PROPOSAL FOR CORRIGENDUM TO PROPOSAL TO DEVELOP AMENDMENTS TO
GLOBAL TECHNICAL REGULATION NO. 9 (PEDESTRIAN SAFETY)
(ECE/TRANS/WP.29/GRSP/2009/21)
BASED ON THE 10TH FLEX-TEG MEETING RESULTS

Note: The text reproduced below was prepared by the expert from Japan in order to propose a corrigendum to proposal to develop amendments to global technical regulation No. 9 (ECE/TRANS/WP.29/GRSP/2009/21) to reflect the 10th Flex-TEG meeting (1st-2nd December 2009) results. The modifications to the proposed amendments to global technical regulation No. 9 (ECE/TRANS/WP.29/GRSP/2009/21) are marked in bold or strikethrough characters.

Figure 13: Flex-PLI; Dimensions and C.G. locations of femur, knee joint, and tibia (Side view)

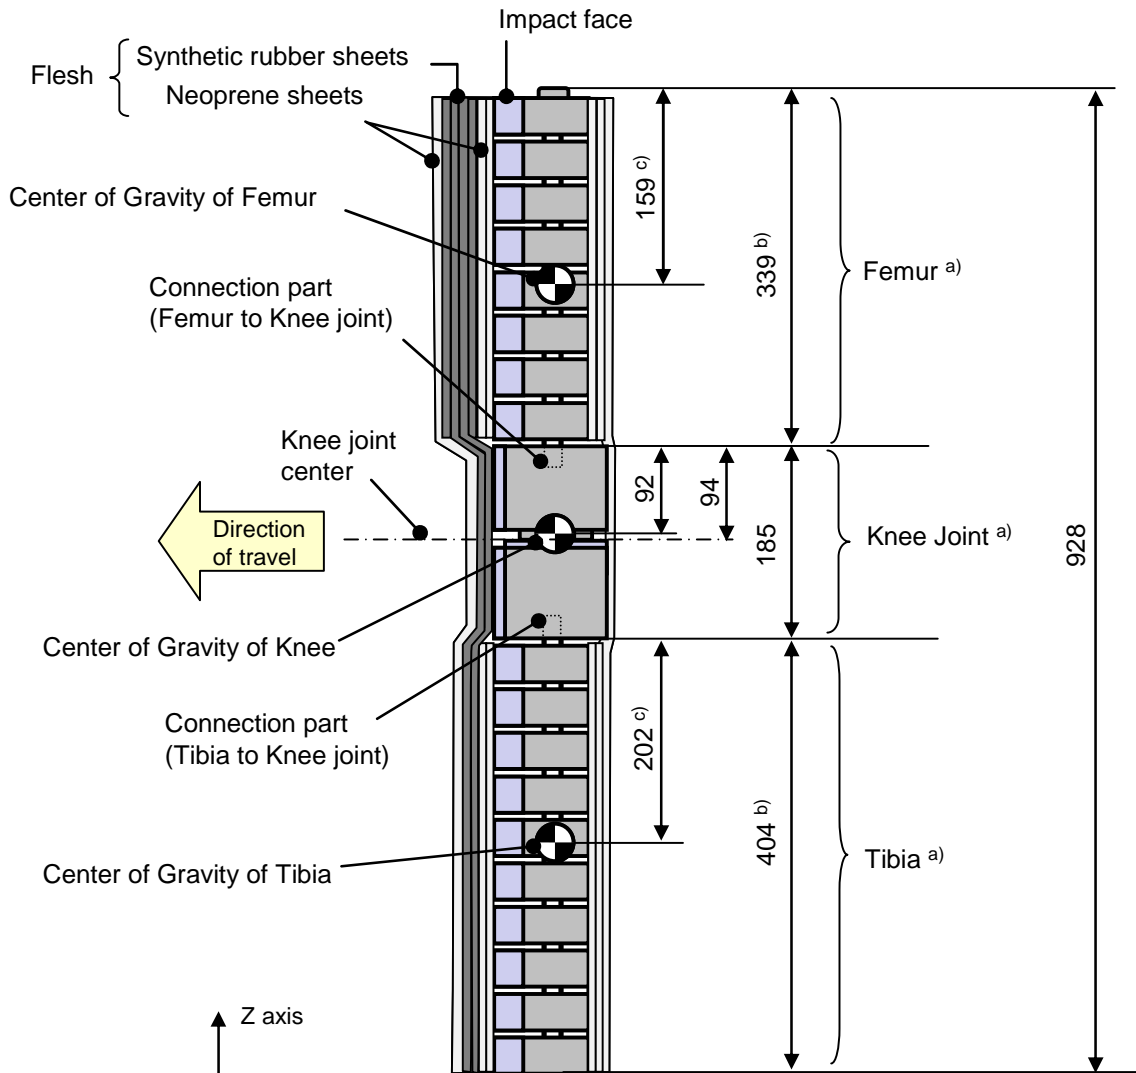
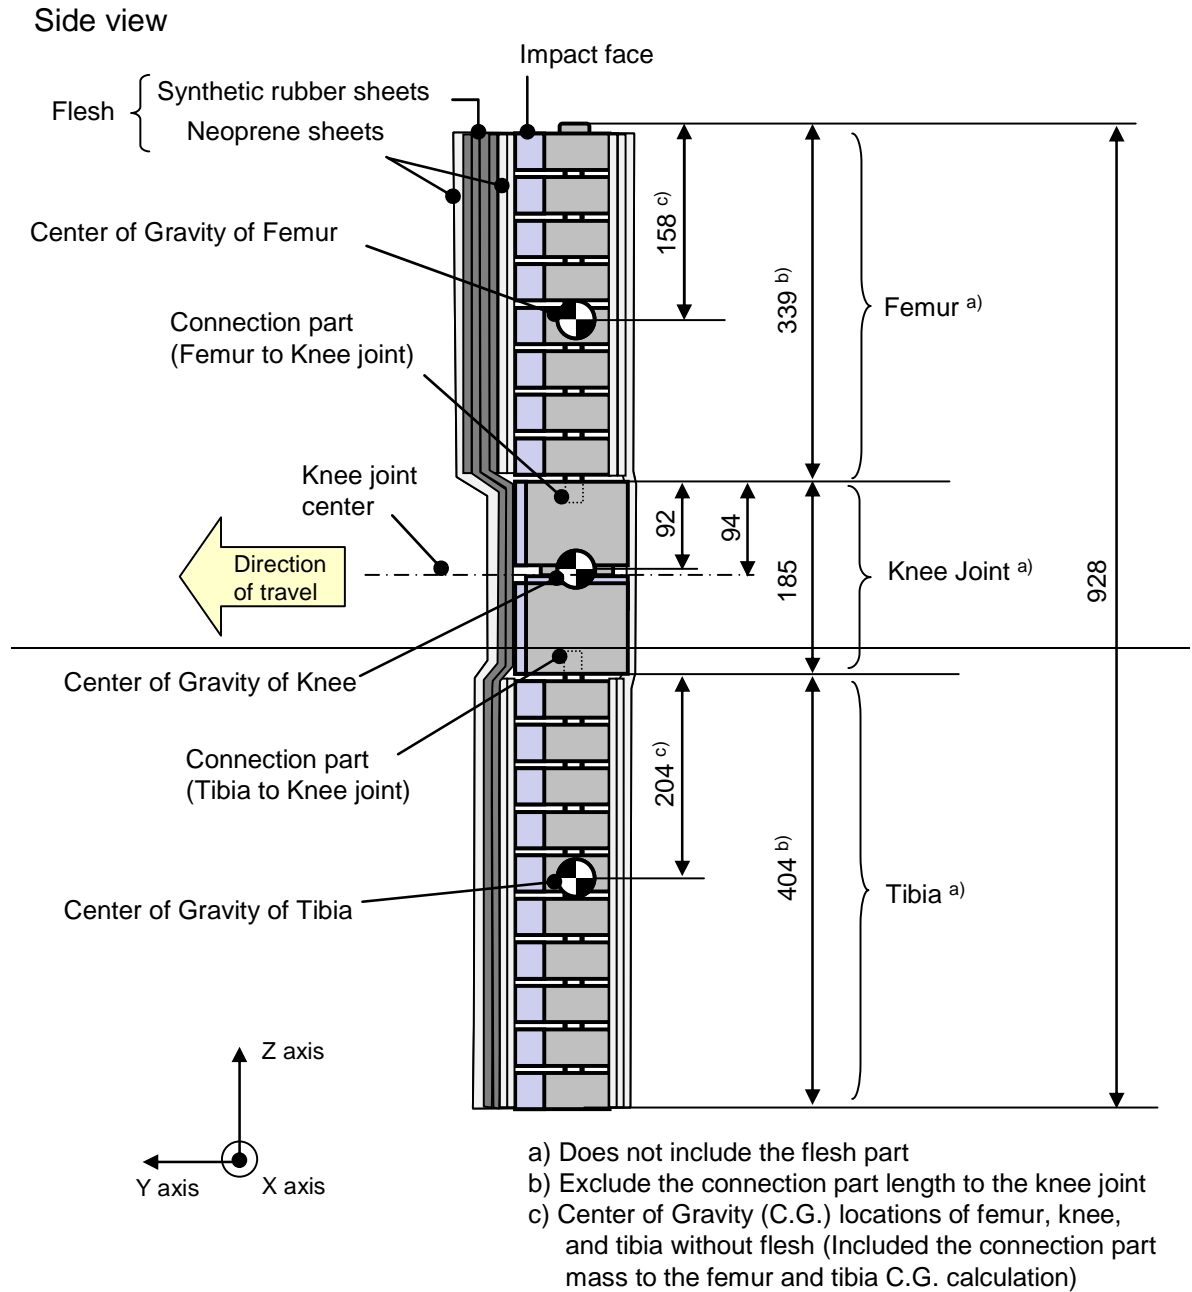
Figures 13., amend to read:

"6.3.1.2.3. The masses of the femur and tibia without flesh, including the connection part to the knee joint, shall be ~~2.47 ± 0.05~~ **2.46 ± 0.12** kg and ~~2.67 ± 0.05~~ **2.64 ± 0.13** kg respectively. The mass of the knee joint without flesh shall be ~~4.34 ± 0.1~~ **4.28 ± 0.21** kg. The total mass of the femur, knee joint, and tibia shall be ~~9.48 ± 0.2~~ **9.38 ± 0.47** kg.

The centre of gravity of the femur and tibia without flesh, including the connection part to the knee joint, shall be ~~$[158] \pm 3$~~ **159 ± 8** mm and ~~$[204] \pm 3$~~ **202 ± 10** mm respectively from the top, but not including the connection part to the knee joint, of each part as shown in Figure 13. The centre of gravity of the knee shall be ~~$[92] \pm 3$~~ **92 ± 5** mm from the top of the knee joint as shown in Figure 13.

The moment of inertia of the femur and tibia without flesh, including the connection part inserted to the knee joint, about the X axis through the respective centre of gravity shall be ~~0.0331 ± 0.002~~ **0.0325 ± 0.0016** kgm² and ~~0.04685 ± 0.002~~ **0.0467 ± 0.0023** kgm² respectively. The moment of inertia of the knee joint about the X axis through the respective centre of gravity shall be ~~0.01818 ± 0.0015~~ **0.0180 ± 0.0009** kgm²."

Figure 15: Flex-PLI; flesh dimensions and mass

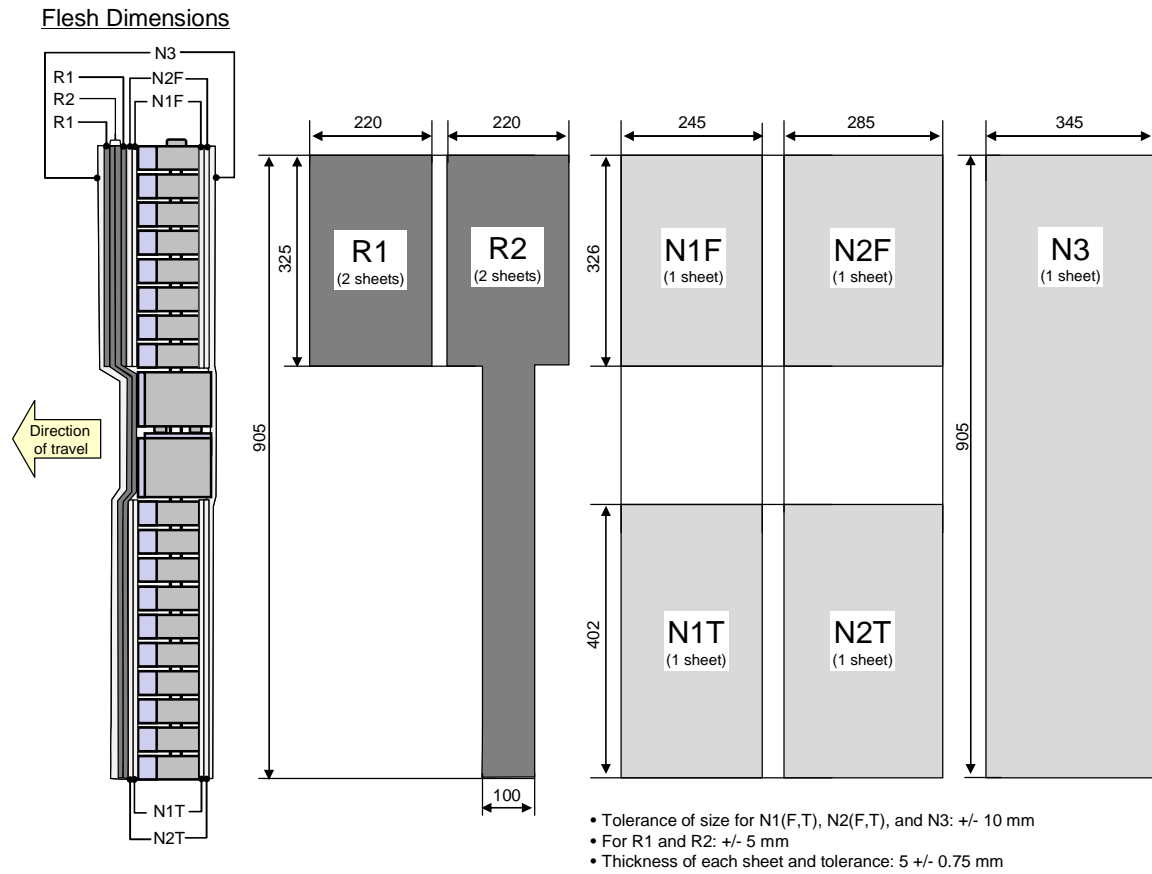
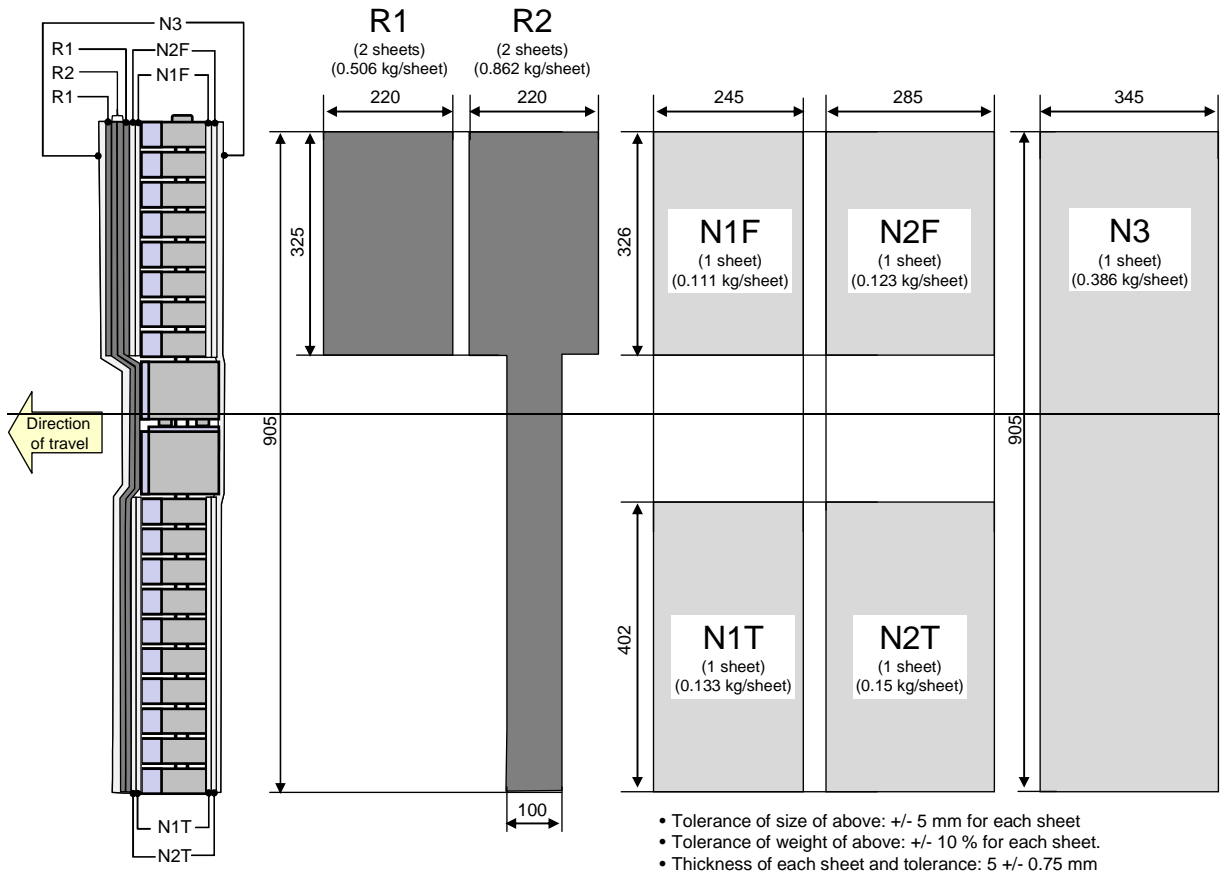
Figures 15., amend to read:

"6.3.1.2.4. For each test, the impactor (femur, knee joint, and tibia) shall be covered by flesh composed of synthetic rubber sheets (R1, R2) and neoprene sheets (N1F, N2F, N1T, N2T, N3) as shown in Figure 15. The sheets are required to have a compression characteristic as shown in Figure 16. The compression characteristic shall be checked using the same batch of sheets as those used for the impactor flesh. The size ~~and weight~~ of the sheets shall be within the requirements described in Figure 16."

Figure 36: Test set-up for dynamic lower legform impactor certification test, Pendulum type (see paragraph 8.2.2.4.) "

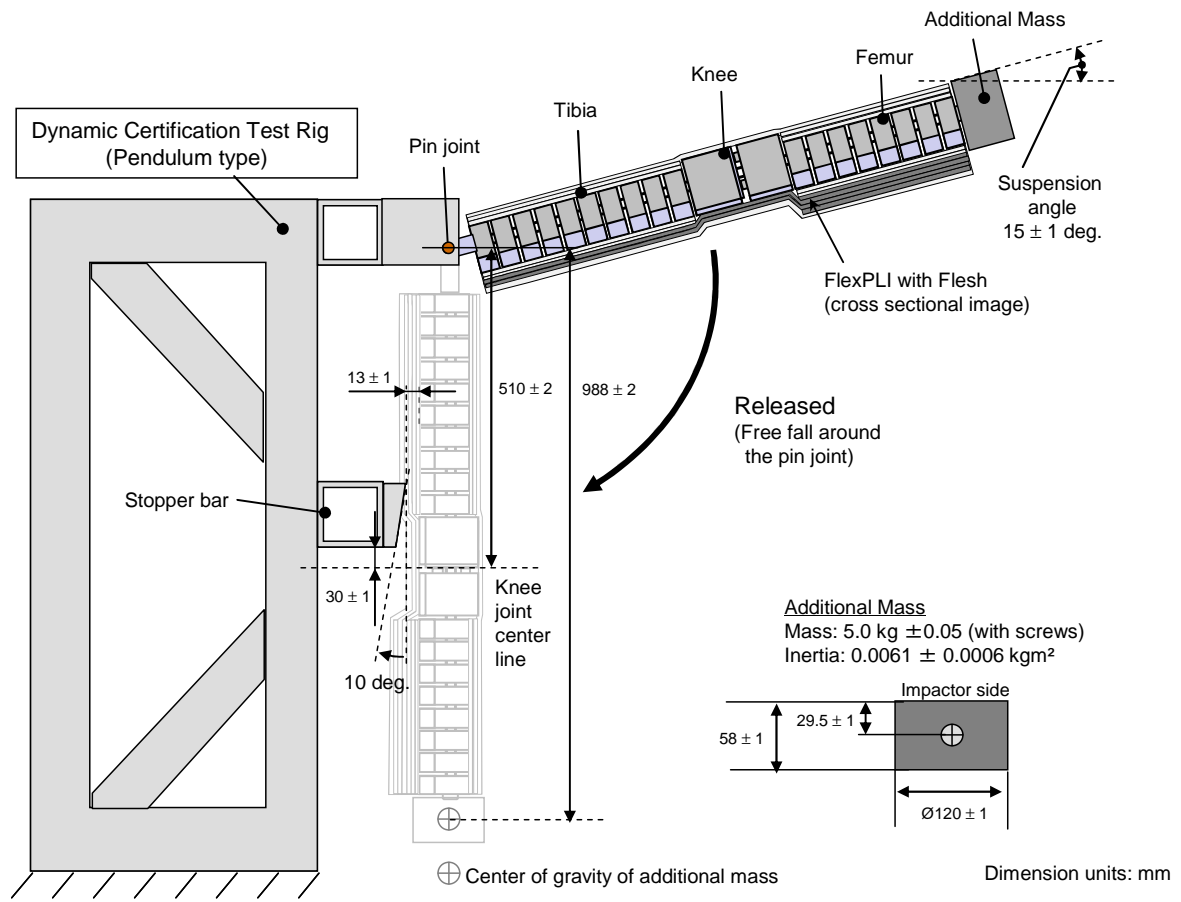
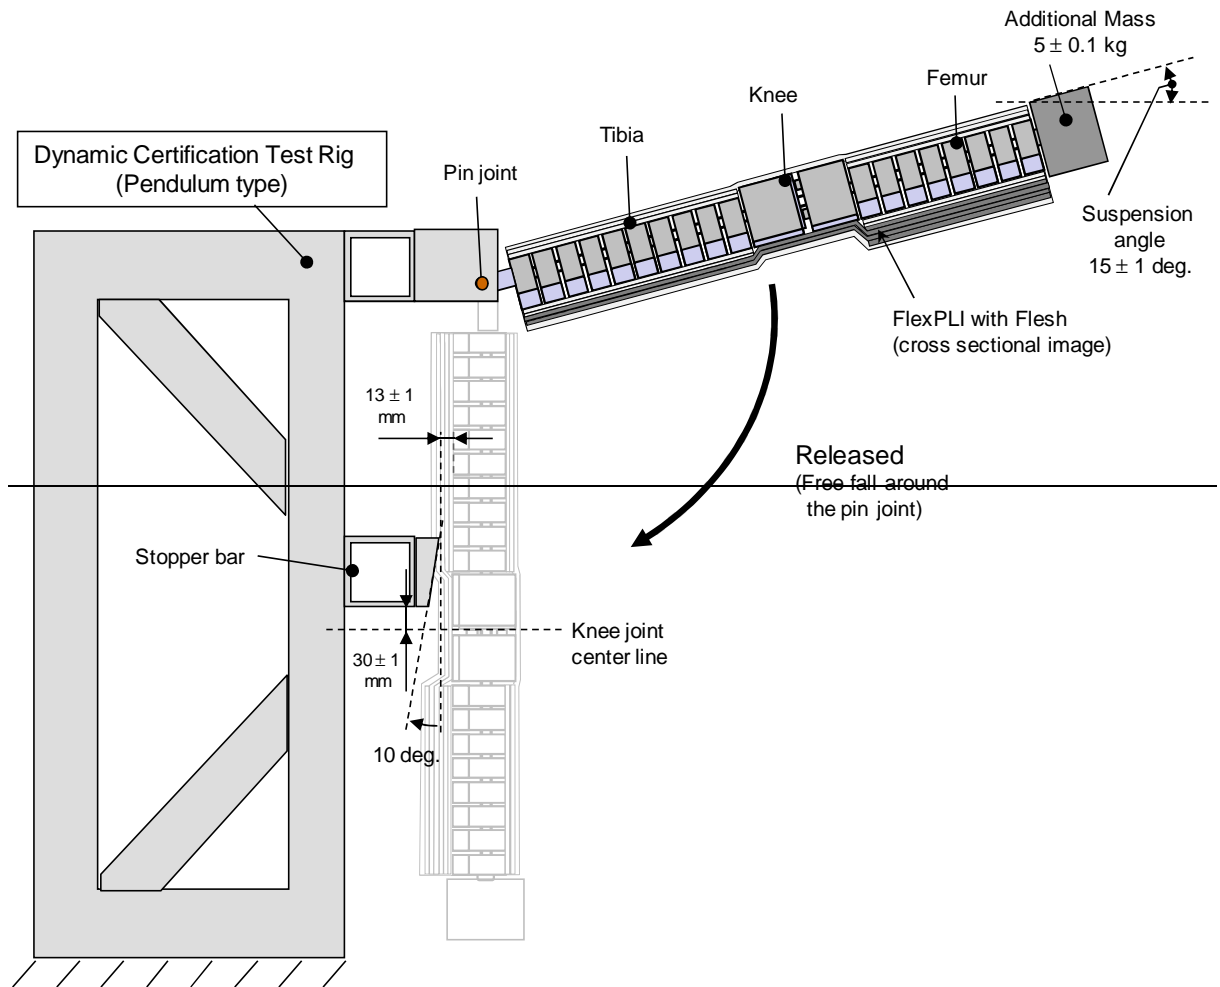
Figure 36., amend to read:

"8.2.2.4.1. The impactor, ~~excluding~~ **including** flesh, shall be suspended from the dynamic certification test rig $15 \pm 1^\circ$ upward from the horizontal as shown in Figure 36. The impactor shall be released from the suspended position, whereupon the impactor falls freely against the pin joint of the test rig as shown in Figure 36. "

Figure 37: Test set-up for dynamic lower legform impactor certification test, Inverse type (see paragraph 8.2.3.4.) "

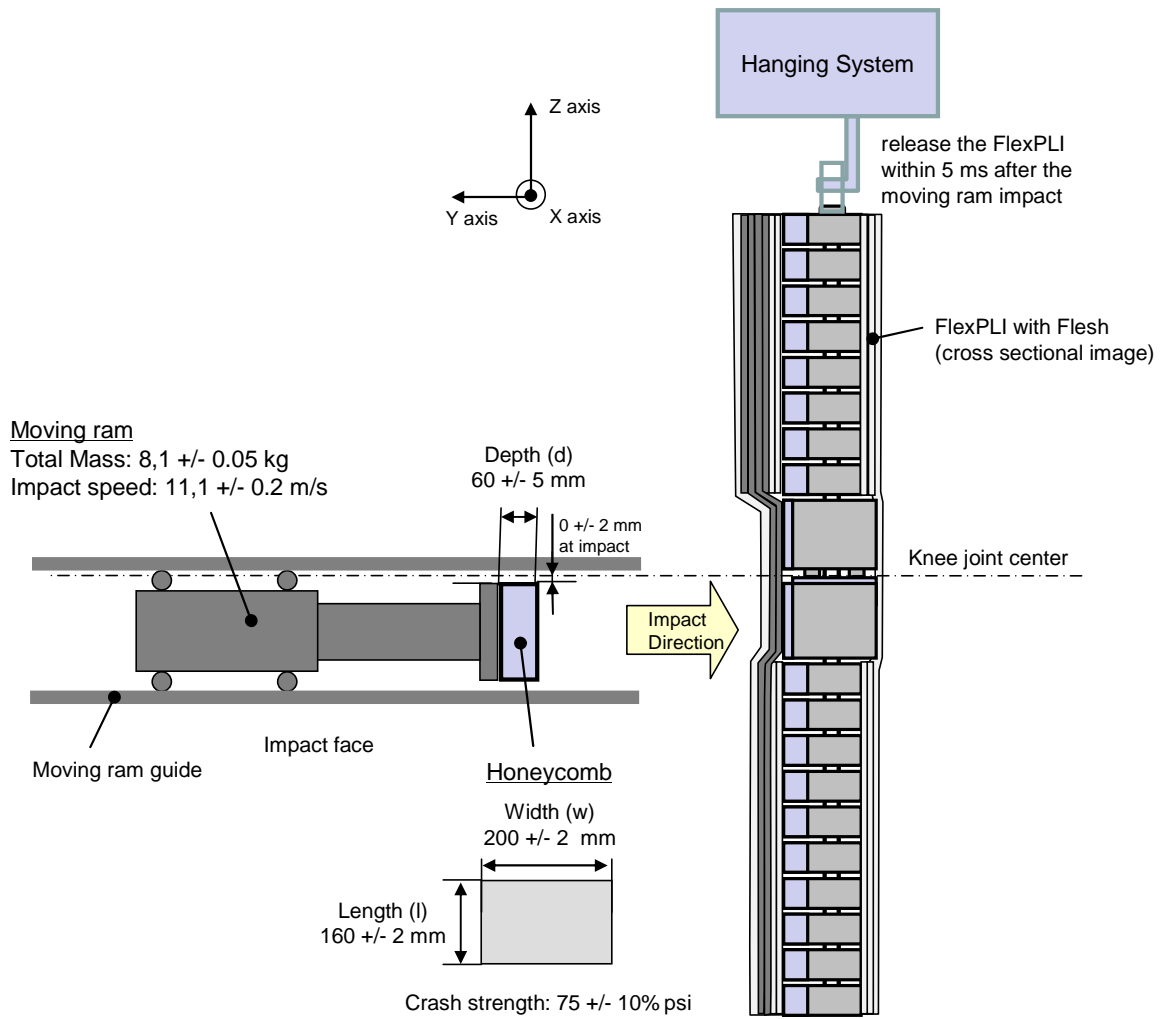
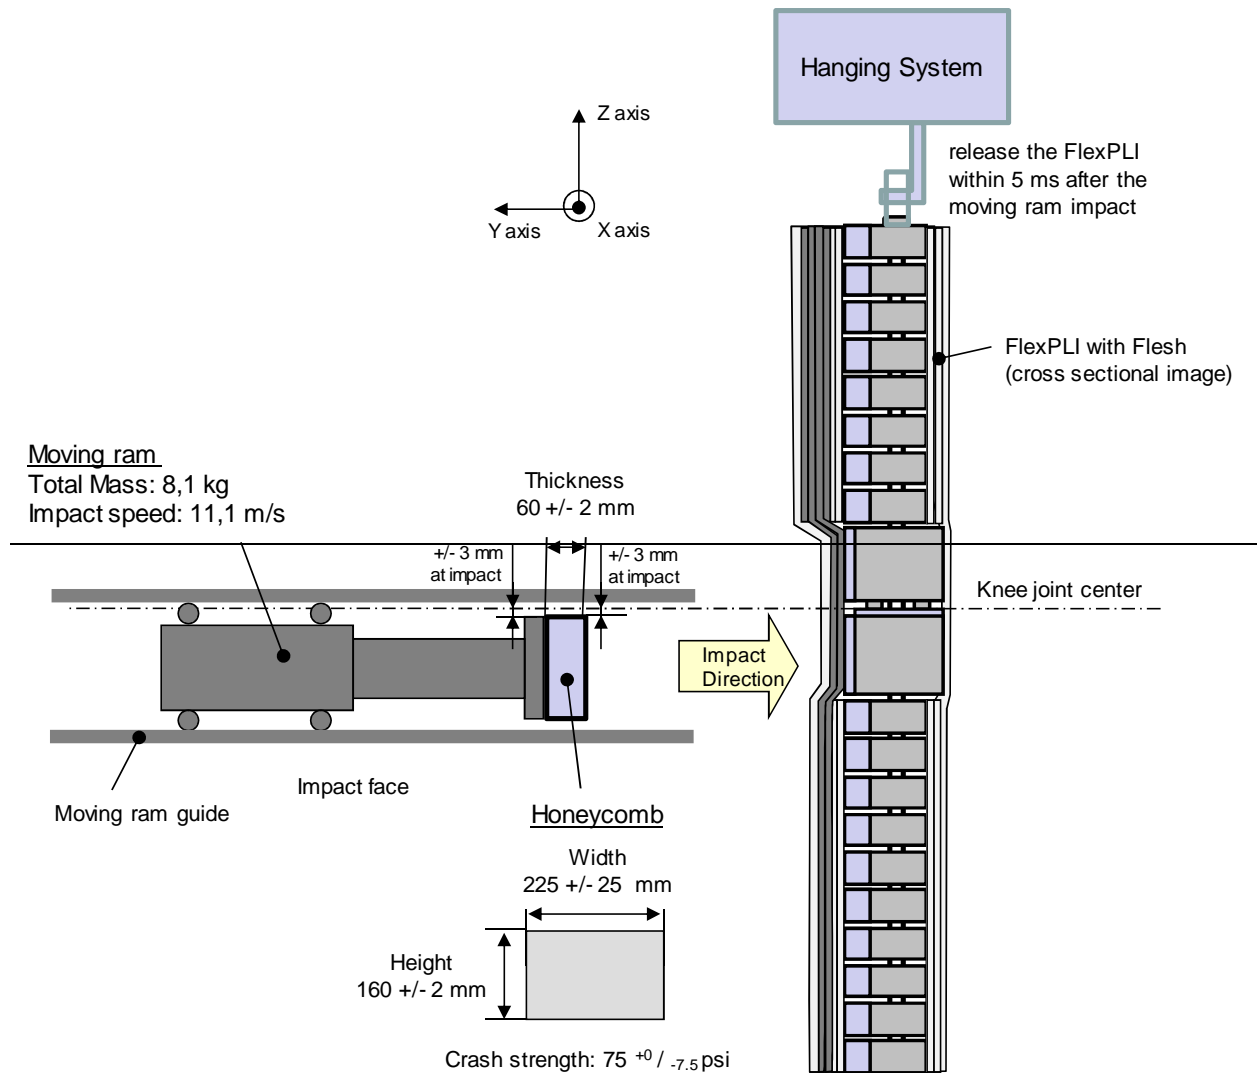
Figure 37., amend to read:

"8.2.3.4.1. **The fully assembled FlexPLI (with flesh and skin) shall be stationary suspended vertically from a test rig as shown in Figure 37. It is then impacted by the upper edge of a linearly guided Al honeycomb impactor , covered by a thin (less than 1 mm thickness) paper cloth, at an impact speed of 11,1±0,2 m/s. The legform is to be released from the test rig within 5 ms after the time of first contact to ensure a free flight condition.**

"8.2.3.4.2. **The honeycomb of 5052 alloy, which is attached in front of the moving ram, shall have a crash strength of 75 ± 10 % psi and dimensions of l=200±2 mm, w=160±2 mm and d=60±5 mm. To ensure a consistent and good level of repeatability, the honeycomb should either have a 3/16 inches cell size in combination with a density of 3.1 pcf or a 1/4 inches cell size in combination with a density of 2.3 pcf or a 3/16 inches cell size in combination with a density of 2.0 pcf.**

"8.2.3.4.3. The upper edge of the honeycomb face is to be in line with the rigid plate of the linearly guided impactor. At time of first contact, the upper edge of the honeycomb is to be in line with the knee joint centre line within a vertical tolerance of 0 ± 2 mm.
